Access Compliance Report

Public Rights-of-Way

(Curb Ramps)

Intersection ID: 14189	Main Street: E_KINGSTON_AV	Cross Street: EUCLID_AV	Location: W
ADA ID: DE170F92C815	Ramp Type: PerpDiag	Initial Pass/Fail: Fail	Overall Compliance: No
Codes/Mitigation Info/Possible Solution		Field Measurements/Component Compliance	
Severity Score: 12.5

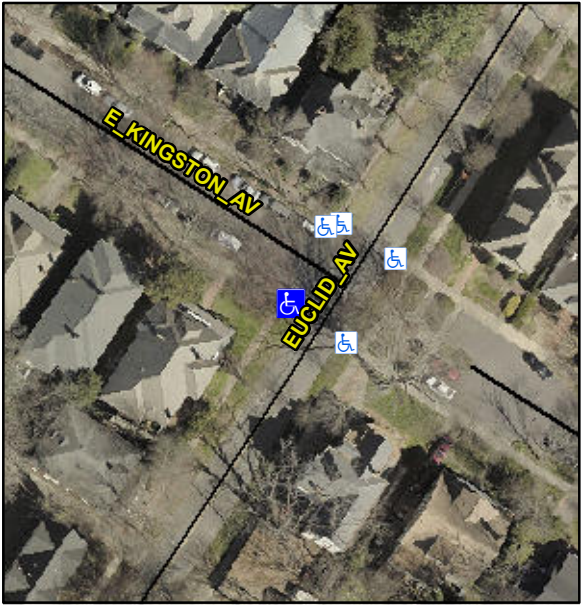
Possible Solutions:	Compliance	Description	Data	Compliance	Description	Data
	Remove & Replace Curb Ramp With Two New Directional Ramps or Equivalent.	N/A	Ramp Length (in)	55.0	No	Ramp Slope (%)	8.8
		Yes	Ramp Width (in)	120.0	Yes	Ramp XSlope (%)	1.0
		N/A	Flare Type LT	N/A	N/A	Flare Type RT	N/A
		N/A	Flare Slope LT (%)	N/A	N/A	Flare Slope RT (%)	N/A
		N/A	Flare Traversable LT?	N/A	N/A	Flare Traversable RT?	N/A
		N/A	Landing Length (in)	N/A	N/A	DWS Provided?	N/A
		N/A	Landing Width (in)	N/A	N/A	DWS Contrast?	N/A
		N/A	Landing Slope (%)	N/A	N/A	DWS Length (in)	N/A
		N/A	Landing X Slope (%)	N/A	N/A	DWS Full Width?	N/A
<p>Surveyor Notes:</p> <p>N/A</p> <p>PROW/ADA:</p> <p>Not Found, R304.2.2</p>		N/A	Landing Curb? (Y/N)	N/A	N/A	DWS Offset (in)	N/A
		N/A	Shared Landing?	N/A			
		N/A	Gutter Ponding?	N/A	N/A	Gutter Slope (%)	N/A
		N/A	Gutter Lip Ht (in)	N/A	N/A	Gutter X Slope (%)	N/A
		N/A	Painted X Walk1?	No	N/A	Painted X Walk2?	No
